DUNDRUM VILLAGE – STRATEGIC HOUSING DEVELOPMENT

TRANSPORT ASSESSMENT

IDENTIFICATION TABLE

Location: Underground Carpark Zone 3

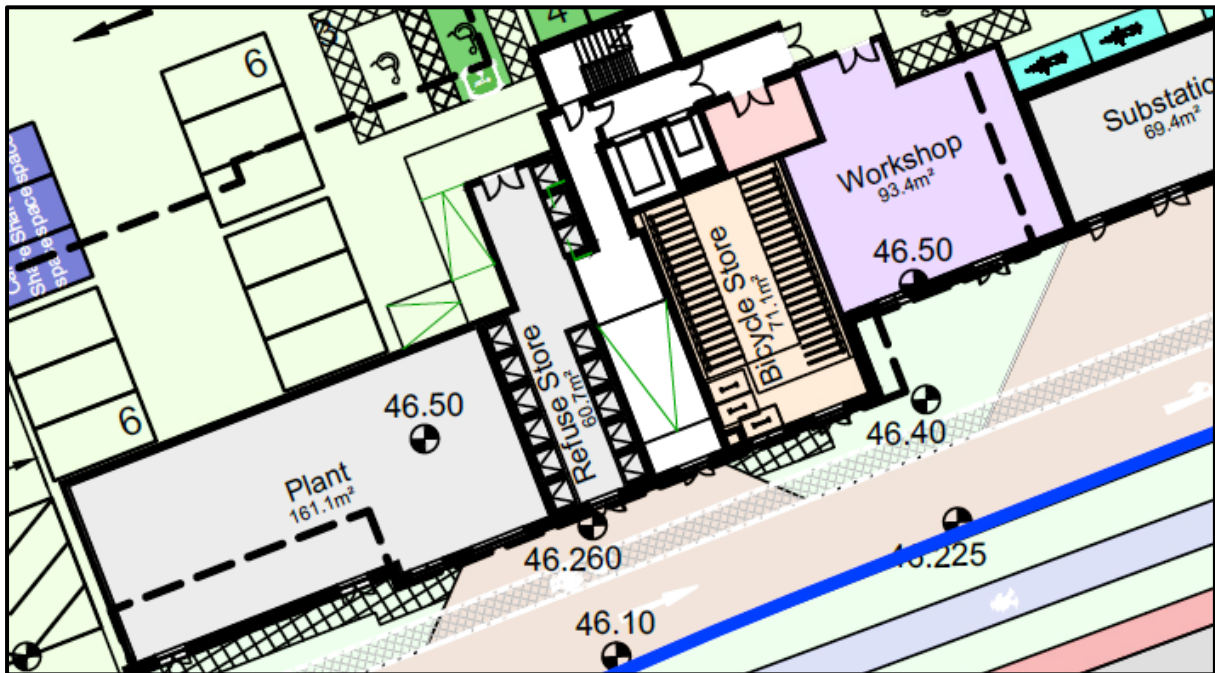
The audit team note that the ramp location is in close proximity to a parking bay. Vulnerable users may be exposed to risk due to the close proximity of vehicle performing parking manoeuvres resulting in injury.

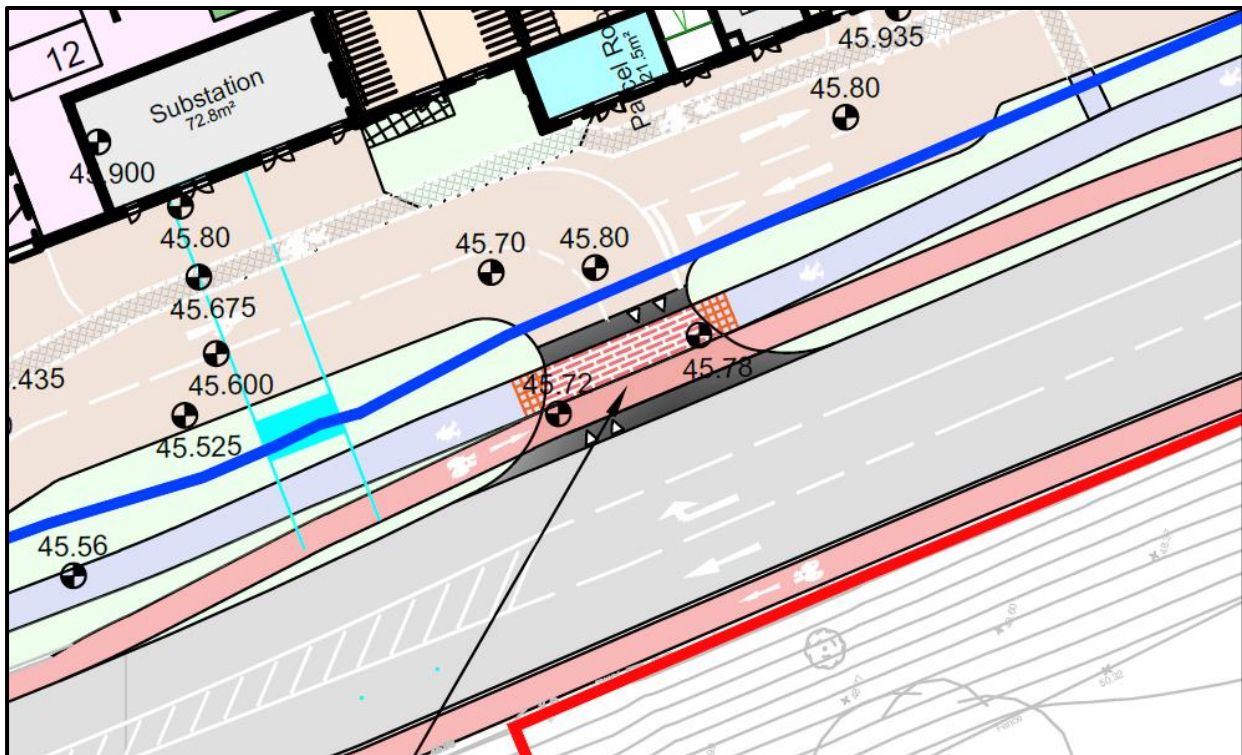
The audit team note from the proposed signage and road marking layouts that there is a lack of traffic control measures and/or regulatory signage and markings for the access junction. It is unclear if exit movements give right of way to pedestrians or cyclists and if vehicles performing exit movements are required to stop/yield before entering the Dundrum Bypass. Vehicles turning right into the development may block exit movements as no yellow box markings are specified to clear exit paths for westbound traffic. Road markings and traffic signals aid in informing road of right of way at access junctions. Inadequate traffic controls may lead to motorists becoming confused as to right of way which could pose a risk of pedestrian/vehicle or vehicle/vehicle collisions resulting in injury.

Recommendation:
